Seismic Walkdown Checklist (SWC)

Equipment ID No.: 1-TDAB

Equipment Description: 250VDC TRAIN 'B' TRANSFER CABINET

Project: DC Cook 1 SWEL

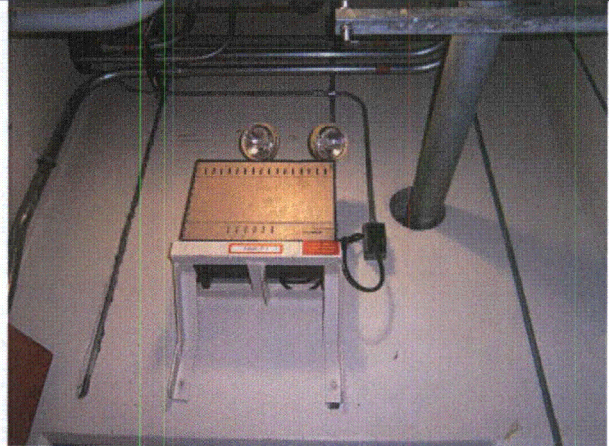
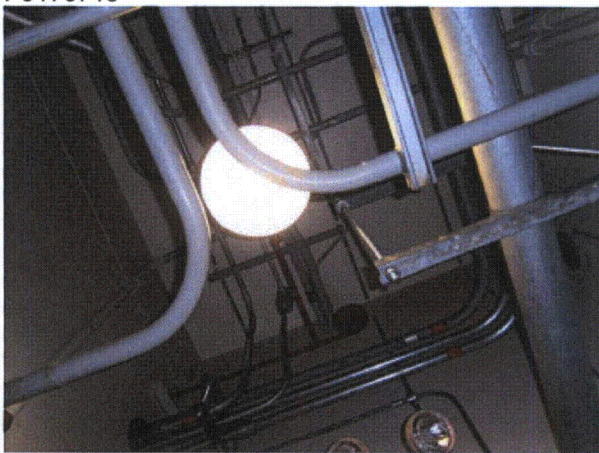
<i>CANNOT OPEN OR SEE ANY ANCHORAGE</i> | Yes |

<i>CANNOT OPEN OR SEE ANY ANCHORAGE</i> | Unknown |

11. Have you looked for and found no adverse seismic conditions that could adversely affect the safety functions of the equipment? Unknown
Could not open due to safety concern

Equipment ID No.: 1-WMO-715

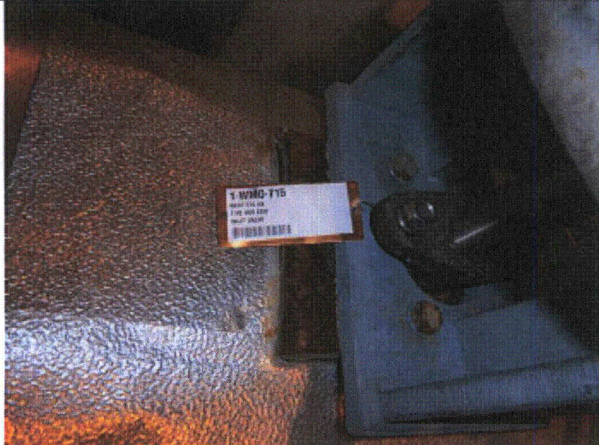
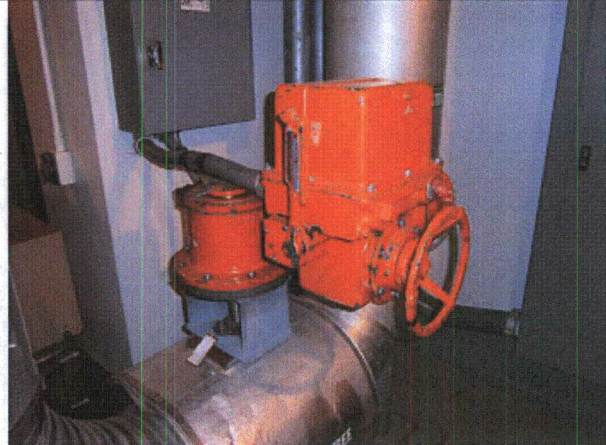
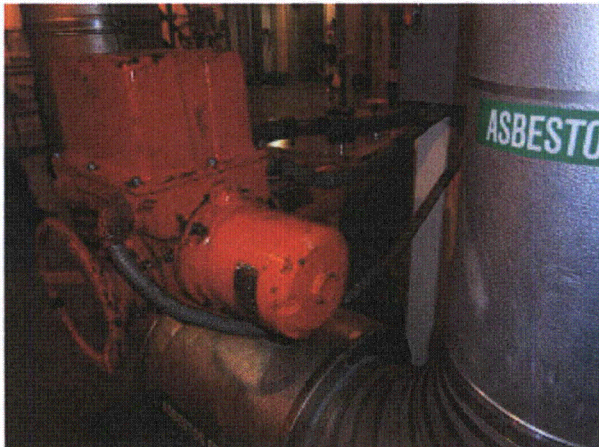
2. Is the anchorage free of bent, broken, missing or loose hardware? Not Applicable
Support for pipe OK by engineering (thread engagement of bolts) Ref DOC# A158433 01

Equipment ID No.: 1-WMO-744

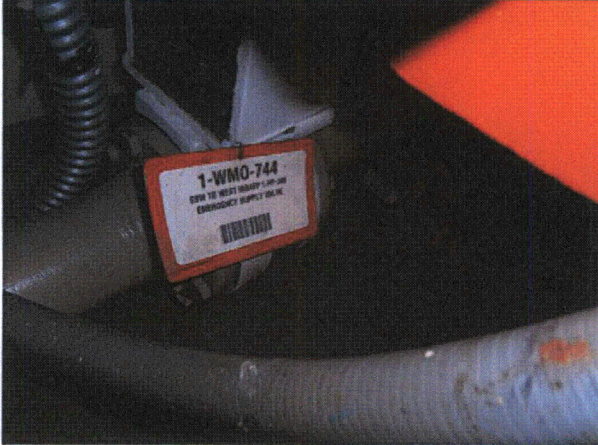
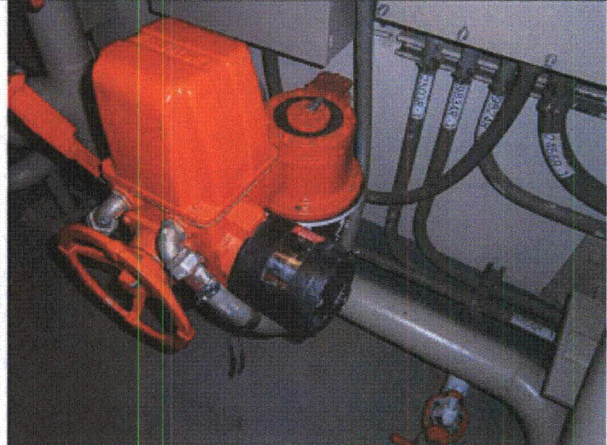
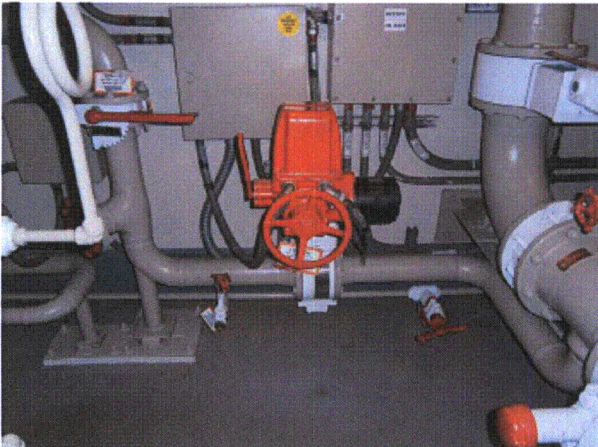
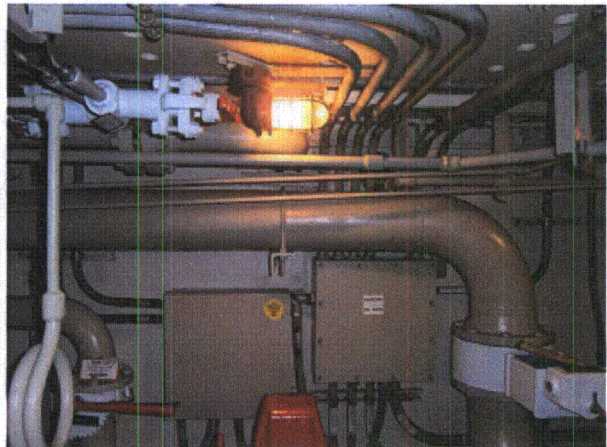
Bottom unistrut left bolt missing, unistrut holds up electrical panel for 1-WMO-744 - Acceptable As Is per CR 99-9360-02

Equipment ID No.: 1-WPA-702

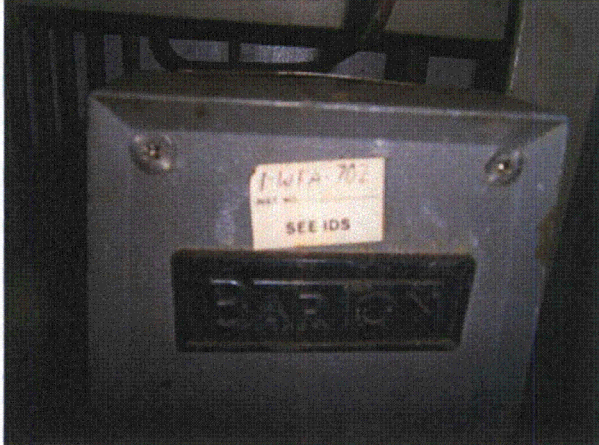
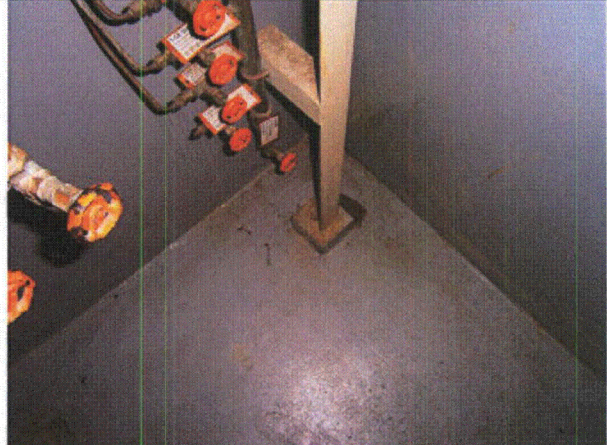
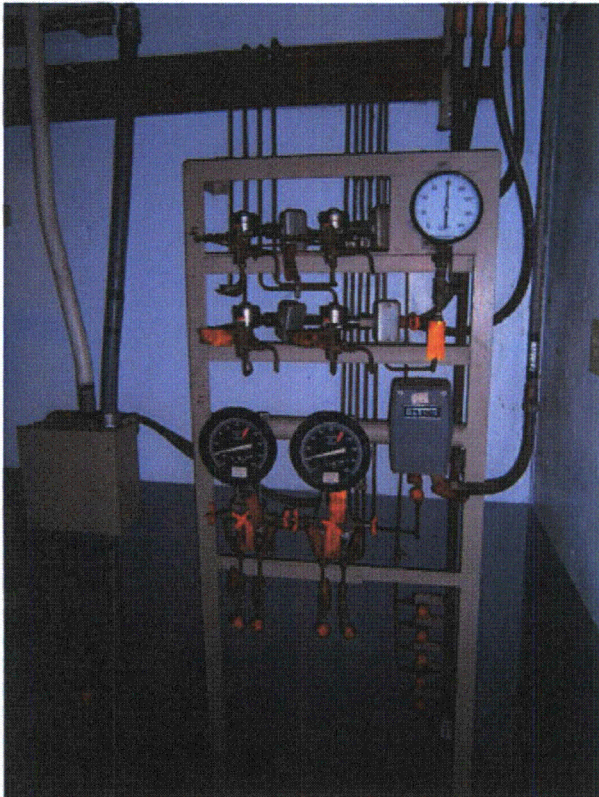
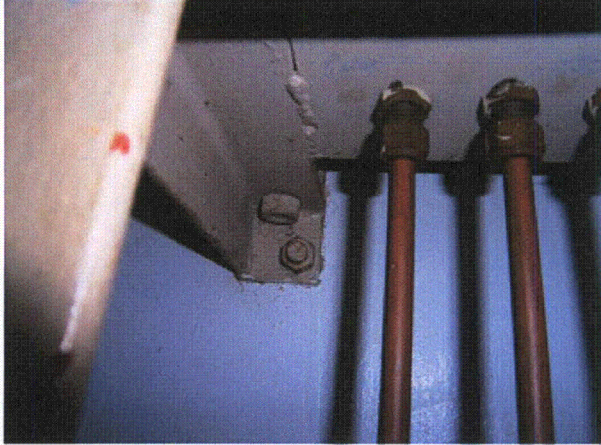
2. Is the anchorage free of bent, broken, missing or loose hardware? Yes
Vertical bolts at top of rack do not have full thread engagement, but are OK, because they are only loaded in shear
